| Description: | Battery technology change project description update |

Project Description Update

#2

Corby Battery Energy Storage System Project

Figure 2-1
Project Layout
(Replaces Figure 1-3)

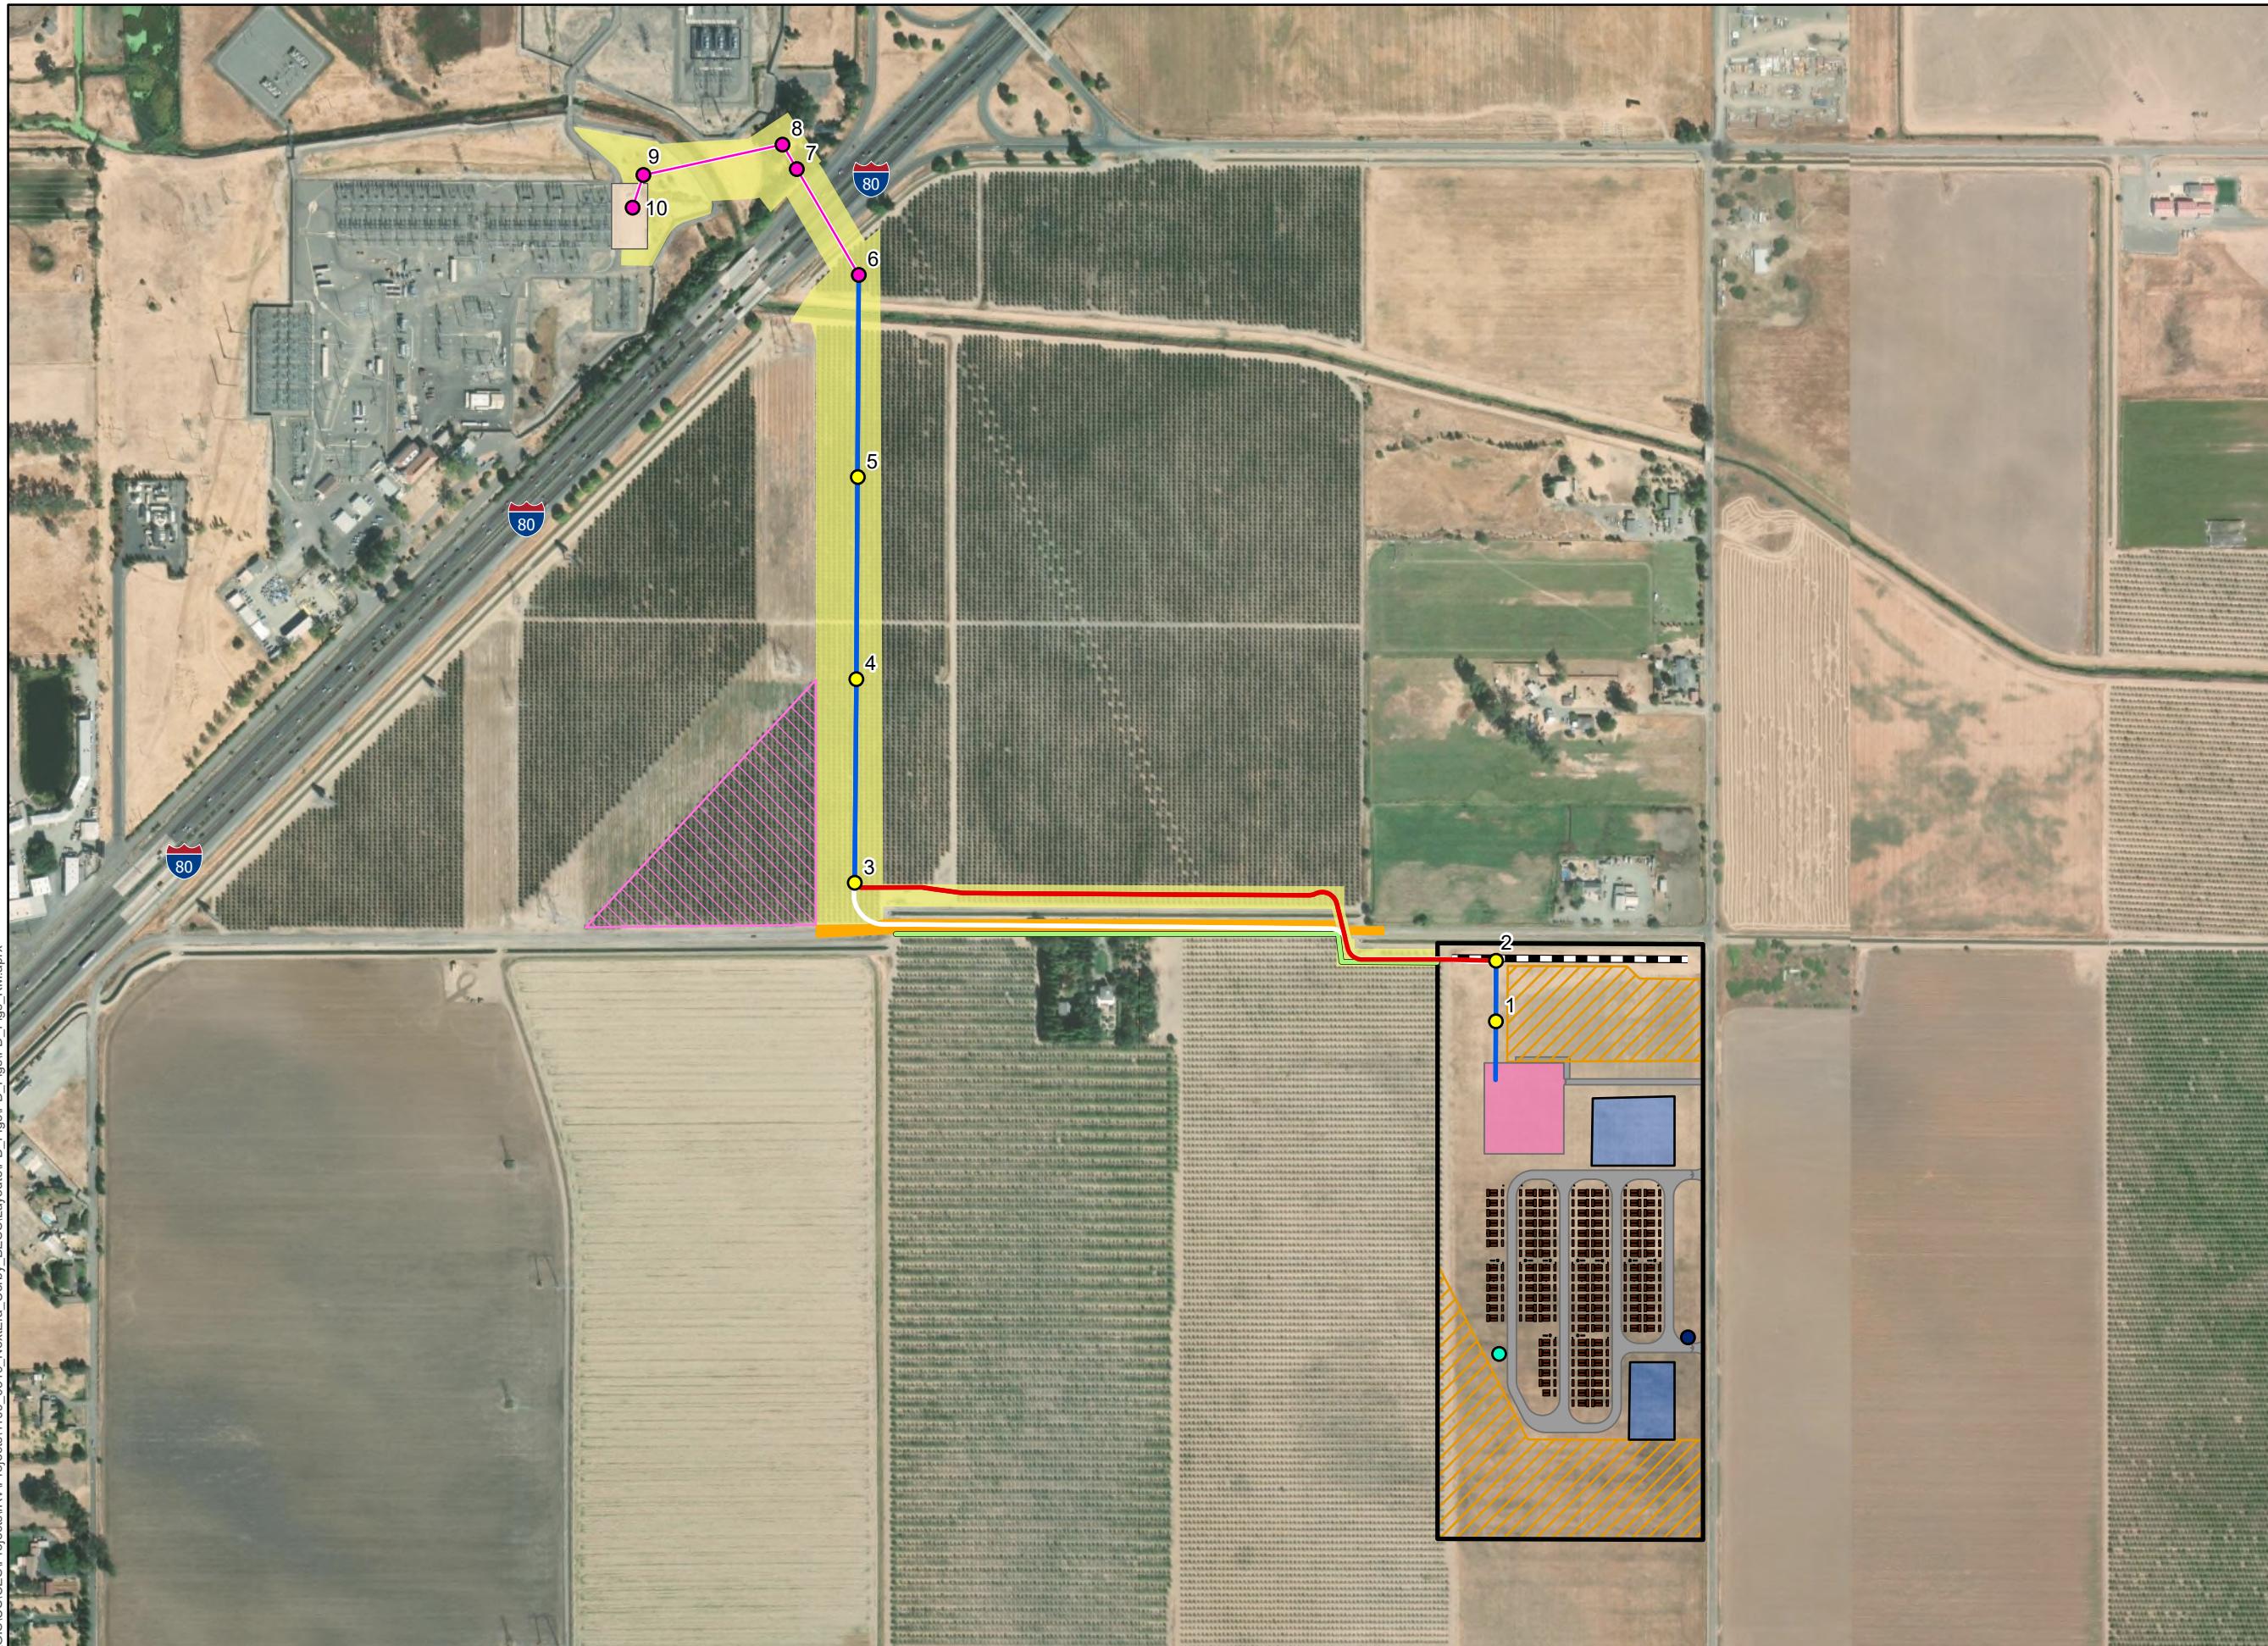
Figure 2-1 depicts the updated Project layout based on the proposed DC Link battery technology. This update also includes minor changes to the equipment within the Project substation, the substation and BESS array fencelines, sizing of stormwater ponds, and access road footprint. The existing site rendering is provided in Figure 2-2, and the proposed site rendering is provided in Figure 2-3. The updated site plan, equipment plan, elevation drawings, and grading plan are provided in Appendix 2-A and reflect the Project Description updates.

on Figure 2-1, the Project will initially include 101 inverters (BOL) and, following full augmentation, will be expanded to 114 inverters at EOL.

Figure 2-4
Grading Comparison

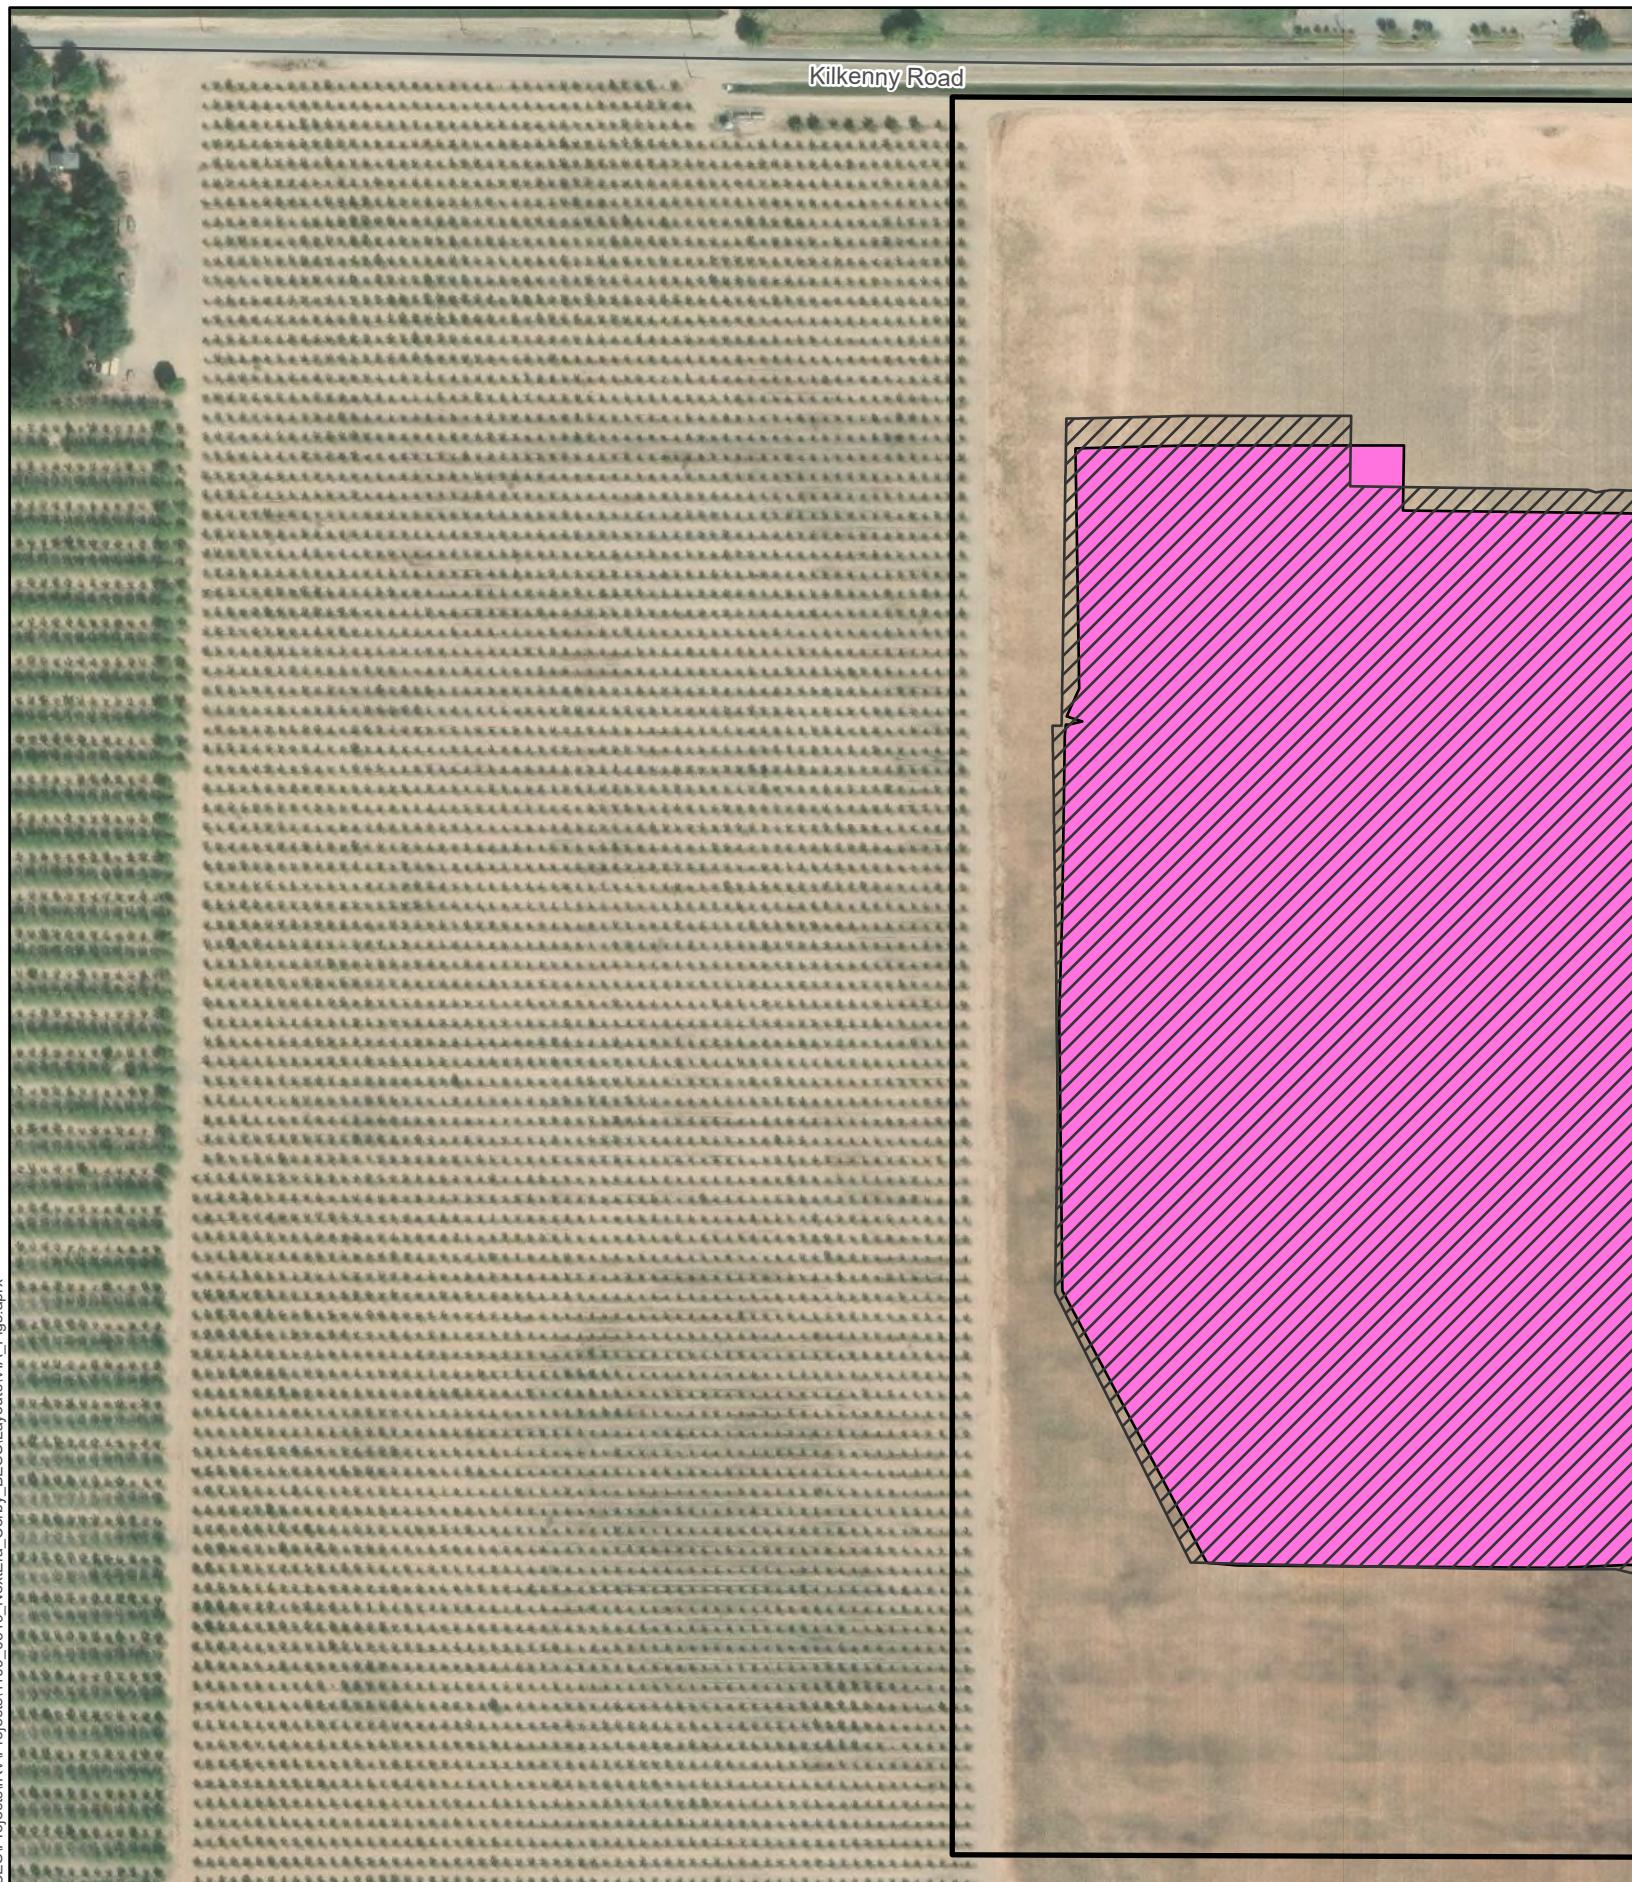
Cumulatively, these changes have resulted in an increase in the grading area from 18.6 acres to 19.6 acres, an increase of approximately 1 acre or 5 percent. Table 2-2 provides a list of the Project features and associated acreage changes as a result of the revised site plan. A figure showing the updated limits of grading relative to the May 2025 Project Description Addendum is provided as Figure 2-4.
